TOWN OF COVENTRY, RI  
DEPARTMENT OF PLANNING & DEVELOPMENT

**STAFF REPORT**

<b>Project Name:</b>	Coventry Centre
<b>Plan Type:</b>	Major Land Development with a Zone Change
<b>Plan Review Phase:</b>	Pre-Application
<b>Owners:</b>	Bernard L. LeFoley Living Trust (Lot 23) David & Christine Olton (Lot 24)
<b>Applicant:</b>	Starr Resolute, LLC
<b>Address:</b>	666 Arnold Rd
<b>Plat / Lot / Zone:</b>	AP 7 Lots 23 and 24 Zone I-1 Lot Size 17 acres
<b>Existing Use:</b>	Single-family house
<b>Proposed Use:</b>	Commercial development
<b>Description:</b>	The applicant is seeking to construct a commercial development with a mix of uses potentially including but not limited to restaurants, retail, grocers, gas stations, convenience stores, coffee shops, and/or service stations.

## TECHNICAL REVIEW COMMITTEE REPORT

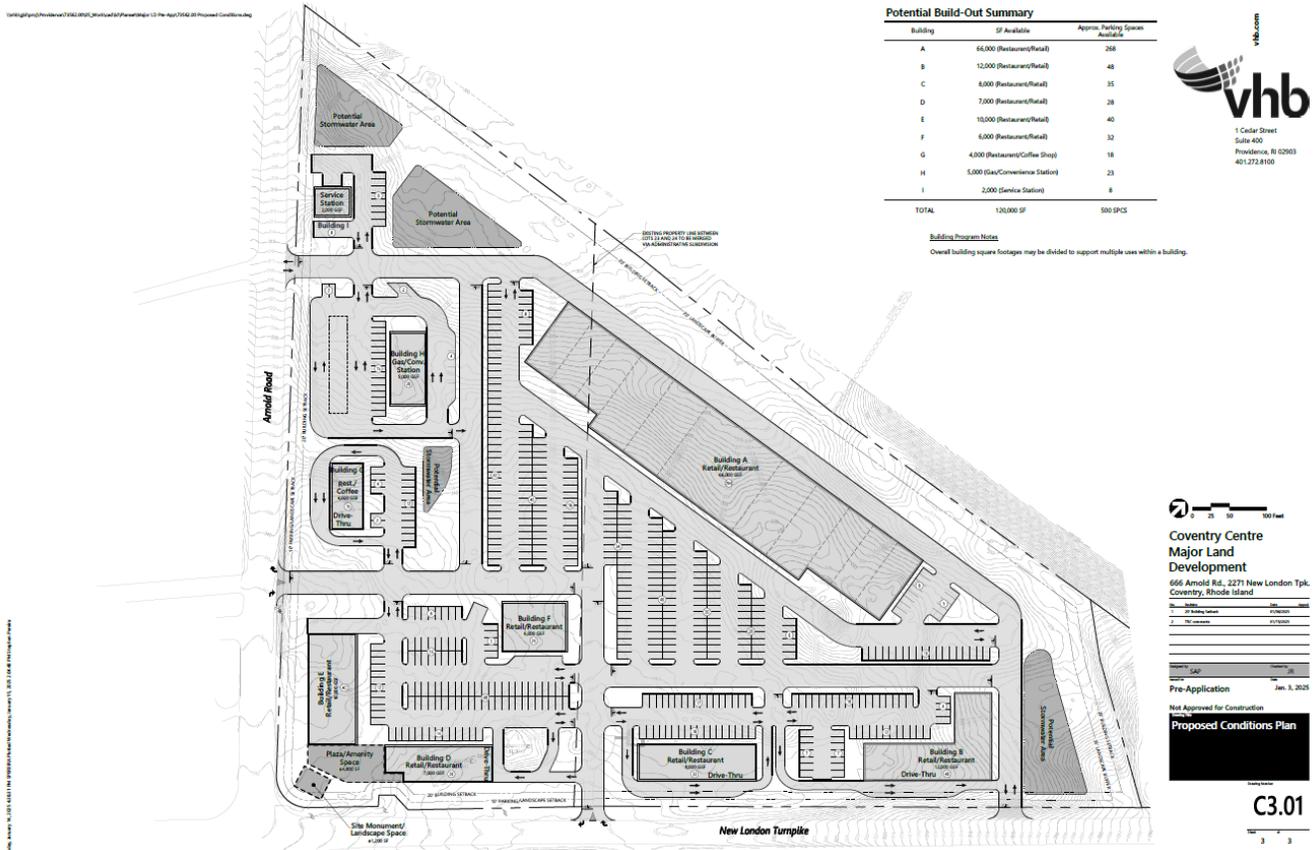
The applicant has submitted a site plan indicating its intent to develop up to 120,000 SF of commercial space on the subject parcel, distributed across nine separate buildings. As currently envisioned, the site design will generally follow the normal “template” for a commercial shopping center, with multiple pad sites located along the roadways orbiting a much larger, multi-tenant building set back from the roads. A small area at the intersection of New London Turnpike and Arnold Road would be set aside for landscaping or some sort of monument to soften the visual impact of the development.

- Planning Staff request the applicant provide an amended or alternative site plan to address the discrepancy between the gross square footage shown on the site plan (106,000 SF) and allowed through the proposed zone change (135,000 SF). Please expand upon the note included in the site plan on this topic with a demonstration of likely or foreseeable site plan alternatives at a conceptual level – for example, would the additional square footage take the form of additional buildings on the site, additional floors on top of building footprints already shown on the plan, etc.

- Planning Staff encourage the applicant to explore opportunities to enhance and provision for pedestrian infrastructure that can support non-automobile access, both internal to the subject parcel and with respect to the parcel's relation to the surrounding roadway network, when preparing its Master Plan submission.

- Planning Staff would like a better understanding of the applicant's envisioned landscaped/natural buffer treatments, particularly in the areas of the property near abutting residential uses, including the yet-to-be built assisted living project to the north.

The Public Works Director stated that he has concerns regarding the traffic congestion in such close proximity to this major intersection. There also needs to be sidewalks installed along the entire property line on Arnold Road and New London Turnpike, along with adequate crosswalks on Arnold Road side. In the parking layout, there does not seem to be ample snow storage areas proposed. A better explanation as to the types of companies that are contemplated.
